DOCKET: 70-0157

LICENSEE: University of Texas at Austin
Austin, TX

SUBJECT: LICENSE AMENDMENT REQUEST SUPPORTING SHIPPING
PREPARATIONS AND AMENDMENT ONE OF SNM-180 (ENTERPRISE
PROJECT IDENTIFICATION L-2019-LLA-0099)

Figure 1. MCZPR fuel elements (18) located in the storage rack (with water reflector/moderator removed) against concrete back and bottom. Note that there are 18 fuel elements present (1x9x2) but appear as 9 due to an intended lack of vertical spacing.

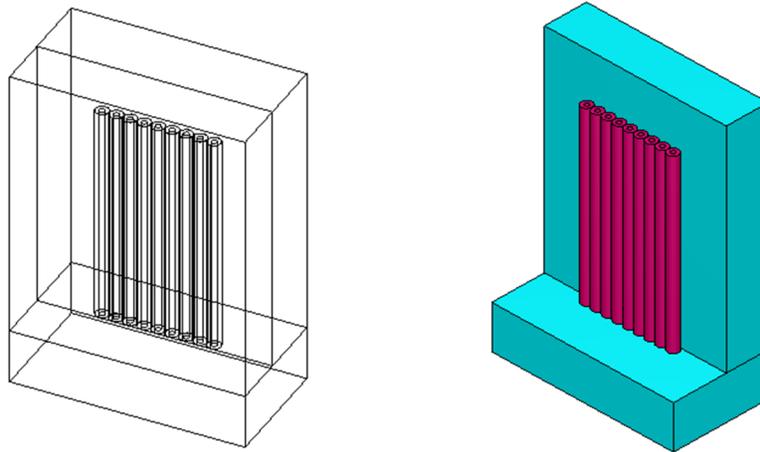
The original analysis of the storage rack was for the MCZPR fuel elements unmodified. NRC staff reviewed the original analyses to determine the potential impact to margin by storing modified MCZPR fuel elements. The original analysis took no credit for the vertical spacing, noting that the actual k_{eff} under these conditions would be less than that calculated due to both the aluminum extensions on either end of the fuel elements increasing the vertical separation of the fuel contained within the elements. Because the original analysis did not take credit for the vertical separation of the fuel, any reduction in the vertical separation should not have a significant impact on reactivity. Nevertheless, NRC staff performed a new analysis to assess the impact to subcritical margin and reconfirm the NRC staff's previous conclusions. The NRC staff evaluated a configuration involving all 17 modified fuel elements located inside the storage rack. The fuel elements were arranged into a 1x9x2 tightly-packed (both vertically and horizontally) array with full-density light water interspersed moderation. An 18th fuel element was added, as was in the original analysis, for symmetry and simplification of calculations. The array was positioned with the bottom and backside directly against Oak Ridge (OR) concrete (density of 2.2994 grams per cubic centimeter), with 12 inches of full-density light water reflection on all remaining sides. No credit was taken for the horizontal spacing between fuel elements provided by the storage rack.

Results of the NRC staff's analysis determined that there was no significant impact to subcritical margin or safety margin, confirmed the NRC staff's previous conclusions (ADAMS Accession No. ML072630617), and demonstrated that the modified MCZPR fuel elements remained adequately subcritical in the unlikely event of full flooding ($k_{\text{eff}} < 0.95$). Therefore, consistent with the NRC staff's previous conclusions, the NRC staff concluded that reasonable assurance is provided for the subcriticality of physically modified MCZPR fuel elements stored in the storage rack (a 1x9x2 array).

Figure 2. MCZPR fuel elements (17) stacked into 4x4 cuboid and pyramid configurations outside of the storage rack (with water removed).

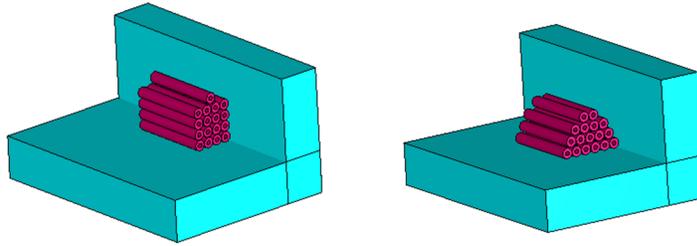
NRC staff evaluated a configuration involving all 17 of the modified fuel elements located outside of the storage rack. The fuel elements were placed into varying arrangements to determine the most reactive geometrical configuration. For all cases, the fuel elements were arranged into a tightly-packed (both horizontally and vertically) array under optimum interspersed moderation conditions, with the bottom (long-side of elements) and one side (long-side of elements) directly against OR concrete and 12 inches of full-density light water reflection on all remaining sides. The configurations specifically considered included:

- A 4x4 array with one element centered on top of the array (17 elements)

- A pyramid consisting of five levels, with levels 1 through 5 containing 6, 5, 4, and 2 elements, respectively (17 elements)

Results of the NRC staff's analysis determined that a configuration involving all 17 fuel elements arranged into a 4x4 array (with one element centered on top of the array) was the most reactive geometrical configuration (likely due to the high surface area-to-volume ratio of a cuboid) and exceeded the $k_{\text{eff}} < 0.95$ criterion. As such, NRC staff performed further calculations to determine how many fuel elements could be stored in a cuboid geometry (under the same moderation and reflection conditions) before posing a criticality concern.

The further analysis performed by NRC staff determined that several (> 7) MCZPR fuel elements would be required before posing a criticality concern. As previously stated, governing NETL procedures require that no more than two fuel elements be outside of the storage rack at any given time (ADAMS Accession No. ML19240A024). Therefore, to achieve a configuration involving several fuel elements stacked outside of the storage rack in an unsafe geometry, multiple administrative failures of qualified NETL staff would have to occur. Notwithstanding a concerted act, NETL staff would not have any reason or motive to violate NETL procedures in such an egregious manner. Additionally, the multiple failures would have to go unnoticed by other NETL staff for some duration, concurrent with full flooding of the area in which the fuel was located.
